Subject: Issuance of Amendment No. 43 to Facility Operating License NPF-10
and Amendment No. 32 to Facility Operating License NPF-15
San Onofre Nuclear Generating Station, Units 2 and 3

ISSUANCE OF AMENDMENT NO.43 TO FACILITY OPERATING LICENSE NPF-10
AND AMENDMENT NO. 32 TO FACILITY OPERATING LICENSE NPF-15
SAN ONOFRE NUCLEAR GENERATING STATION, UNITS 2 AND 3

AMENDMENT TO FACILITY OPERATING LICENSE

ATTACHMENT TO LICENSE AMENDMENT NO. 43

Figure 3.1-1

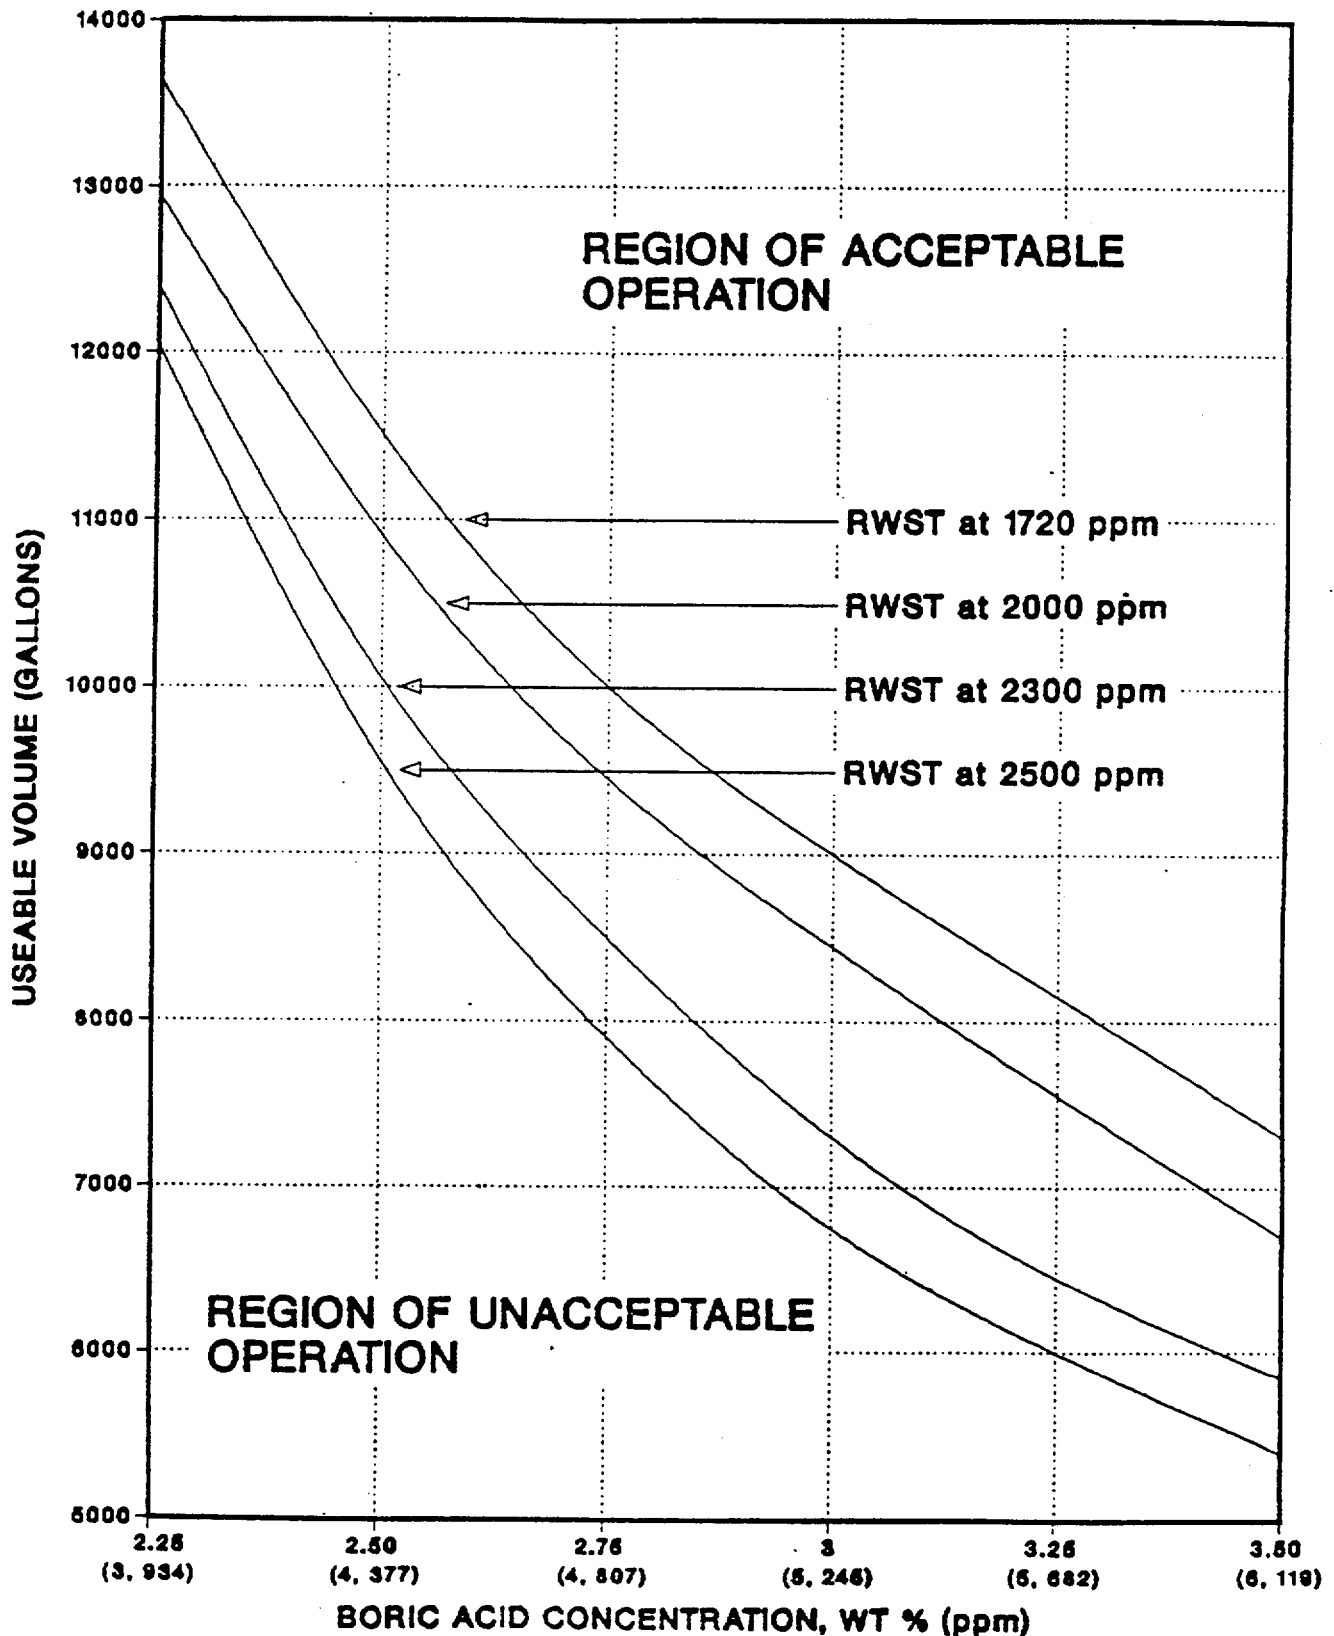
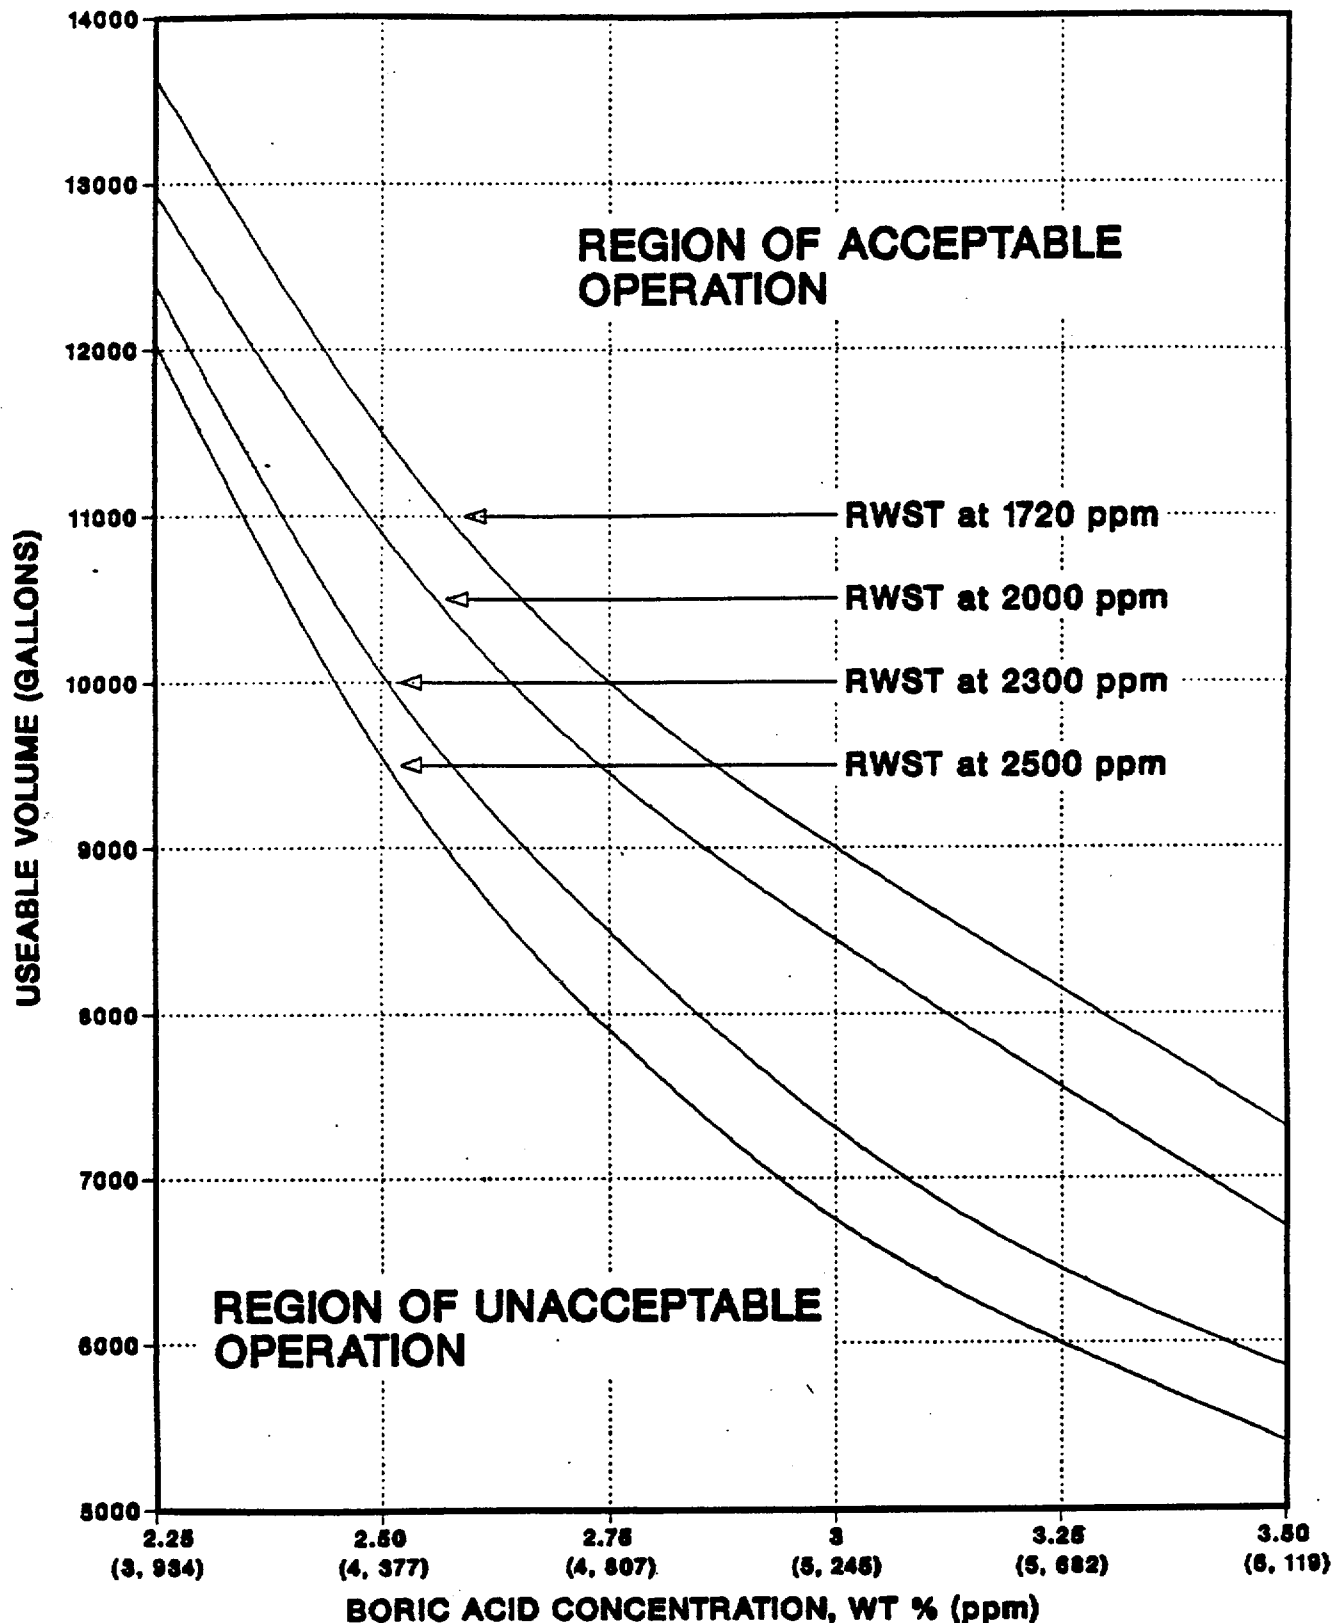
Figure 3.1-1 (for Operating Modes 1 to 4)

This figure specifies the minimum required BAMU water volume and temperature as a function of stored boric acid concentration for the various plant

operating modes. The revised figure specifies the minimum required water volume (contained in one or both BAMU tanks) as a function of boric acid concentration for a given boron concentration in the RWST. The range of boron concentration in the BAMU tank has been reduced from 8.5-12 weight percent boric acid to 2.25-3.5 weight percent.

This technical specification requires that at least one BAMU tank and its associated heat tracing be operable with the contents of boric acid in the tank to be in accordance with Figure 3.1-1. Figure 3.1-1 requires a minimum volume of boric acid of 5450 gallons at a concentration of 8.5 weight percent to be maintained in the BAMU tank. The technical specification also requires that the RWST be operable, containing a minimum of 362,000 gallons borated water with the boric acid concentration between 1720 and 2300 ppm.

The proposed changes would reduce the range of the boric acid concentration as specified in the revised Figure 3.1.1. Also, the concentration of the borated water in the RWST would be changed to range between 1720 and 2500 ppm while the boric acid volume is maintained unchanged. The surveillance requirement to verify the BAMU tank solution temperature would be deleted.

The proposed changes are consistent with the analytical results (as discussed above for plant conditions in Operating Modes 1 to 4, will maintain the required safe shutdown margin, and are therefore acceptable.

We conclude that the revised Figure 3.1.1 is acceptable since the analytical results discussed in Section 2 above support the changes. The change of upper limit from 2300 to 2500 ppm for boron concentration in the RWST is acceptable since boric acid at a concentration of 2500 ppm will not precipitate at temperatures higher than 32°F. Based on this we conclude that the change will not result in boron precipitation in the RWST nor in the Reactor Coolant System after a LOCA. The deletion of the surveillance requirement on the BAMU solution temperature is acceptable since the concentration of the BAMU solution is low and precipitation will be avoided at ambient temperature.
